Meeting name	Supplier Volume Allocation Group
Date of meeting	04 August 2009
Paper title	Change Proposal Progression
Purpose of paper	For Decision
Synopsis	This paper provides: <ul style="list-style-type: none">• 8 Change Proposals (CPs) for decision;• an update on the Gross Volume Correction (GVC) Draft Change Proposals (DCPs); and• details of the status of all Open Draft Change Proposals (DCPs) and Change Proposals (CPs).

- **AGREE** our suggested amendments to the redline text for CP1267 version 1.0 (shown in table 3 of Appendix 1).
- 2.2 CP1288 – Revisions to Meter test points within Code of Practice 4

Figure 1: Example showing Type A Calibration Points for a CoP1 and 2 Reactive Energy Meter

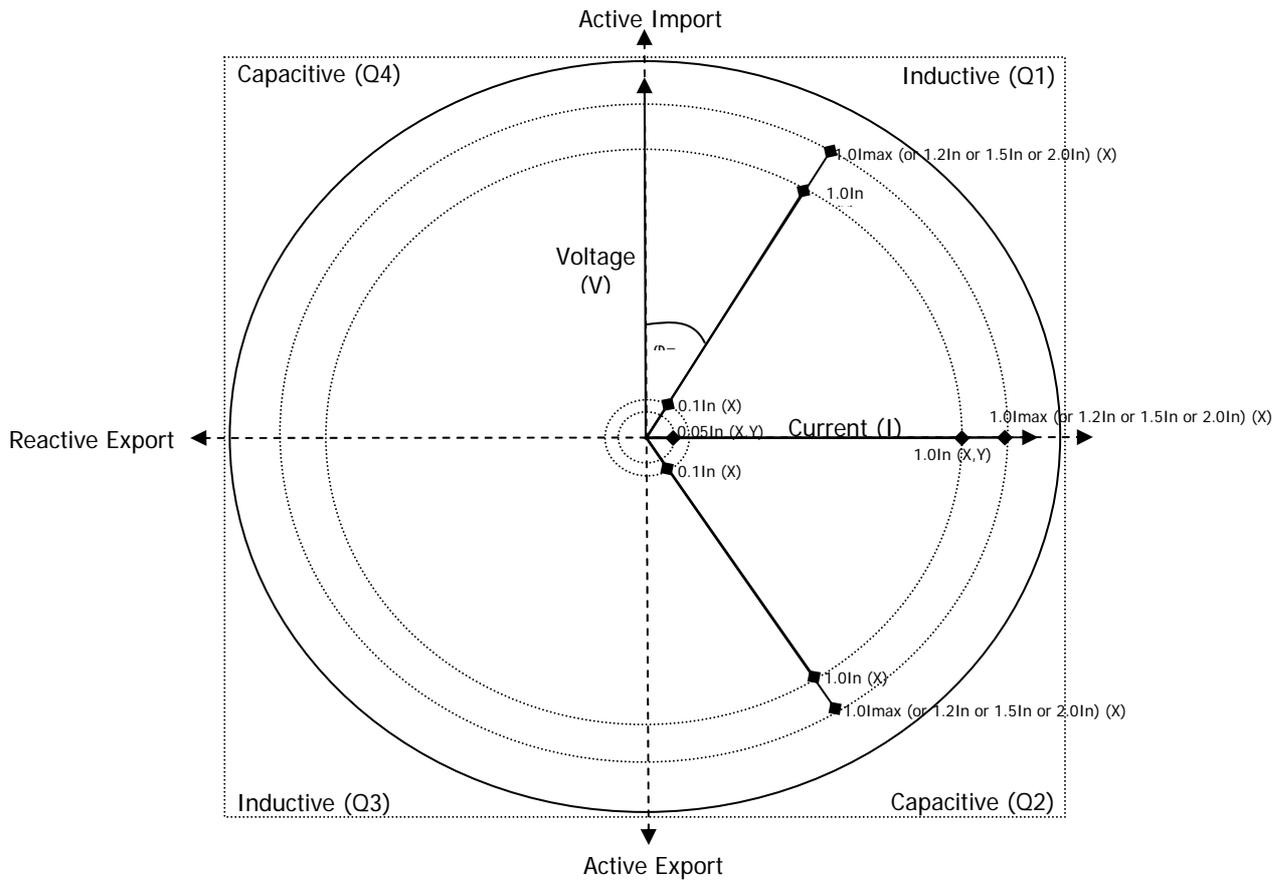
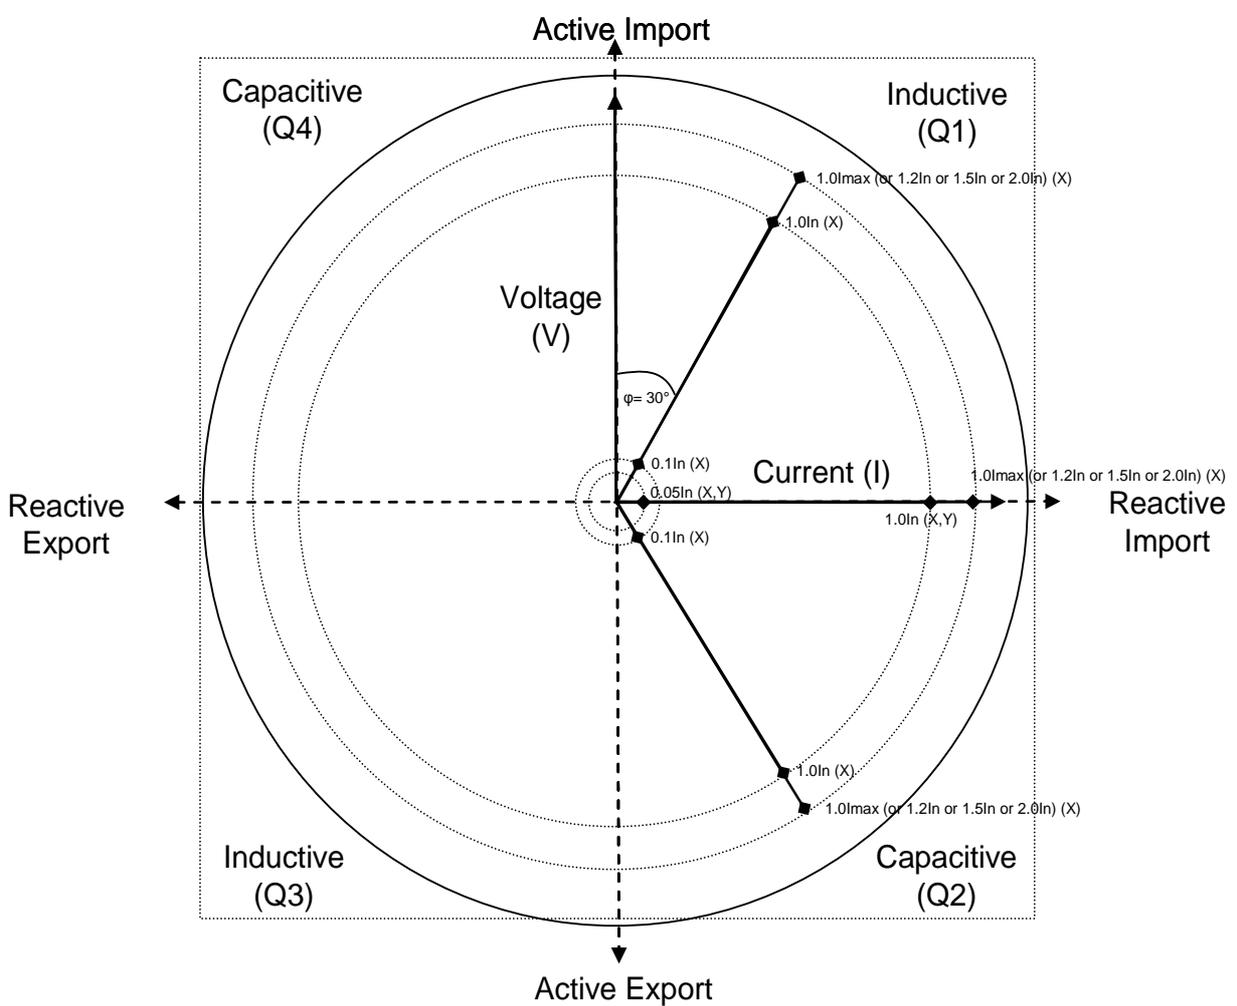
Inserting of a new diagram (Figure 1) into Appendix B to clarify the test point requirements for CoP 1 and 2 Reactive Meters

- 4.4 Additionally, a respondent suggested that the vector diagram in the British Standard 'BS EN 62053-23' is used within CoP4. We recommend that the SVG agree that the vector diagram contained in Appendix C of BS EN 6253-23 should replace the vector diagram that was issued during the impact assessment of CP1288.

No	Organisation	Document name	Location	Severity Code ¹⁰	Comments	ELEXON Recommendation
1	Cewe Instrument AB	CoP4	App 1 table B1 vector diagram	H	Internationally recognised standard diagram to be used.	As detailed in our response to Cewe in the table above, ELEXON recommends that the vector diagram from BS EN 6253-23 is used in place of the diagram issued for impact assessment.
2	Cewe Instrument AB	CoP4	App 1 Table B1	M	Are single phase load points required for 3ph 3wire networks?	Please see our response to Cewe in the table above. We also confirmed with the respondent that no changes will be required to the redline text.
3	British Energy	CoP4	Tables B1, B2, B3, B4, B5	M	For consistency with proposed changes to the headings for Reactive Meters and Active meters on Table C1(a), and with existing headings on Tables C1 & C2, it is suggested the headings for Active meters be amended to include reference to "(Cos Ø)"	Comment noted. ELEXON recommend that the SVG agree that amendment is made, as it adds further clarity to the proposed redline text. Therefore all remaining references to 'System power factor' in tables B1 to B5 should be replaced with Cos Ø.

- 4.3 Some respondents suggested minor changes to add further clarity to the proposed redlined text (see comments in table 2 and 3 below). We agree with these comments and recommend that the SVG agree that the redline text should be amended to include them.
